# Seattle Design Commission

## **MINUTES OF THE MEETING**

**August 3, 2006**

## 03 August 2006 Project Colman Dock Redevelopment

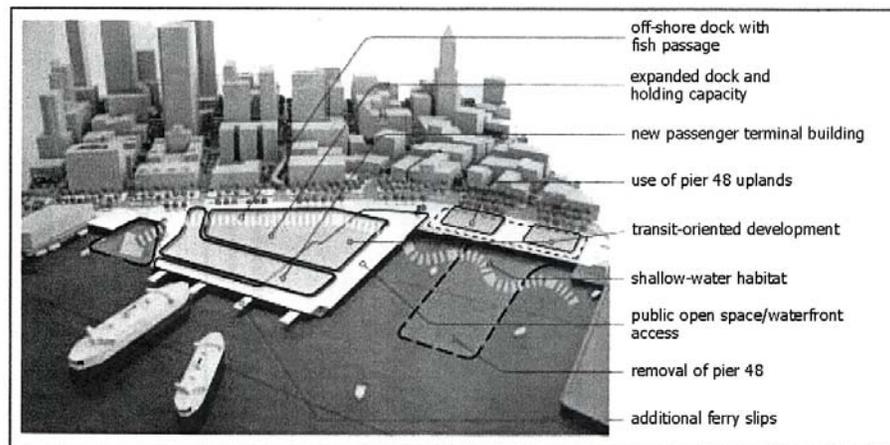
- **Encourages pedestrian nodes at vehicular entries and exits**
- **Urges continued distinction and preservation of public views, especially relating to Alaskan Way**

- **Among the early concept massing options presented, prefers the more iconic, tall/thin design versus the low/flat design**
- **Thanks team for the excellent model**
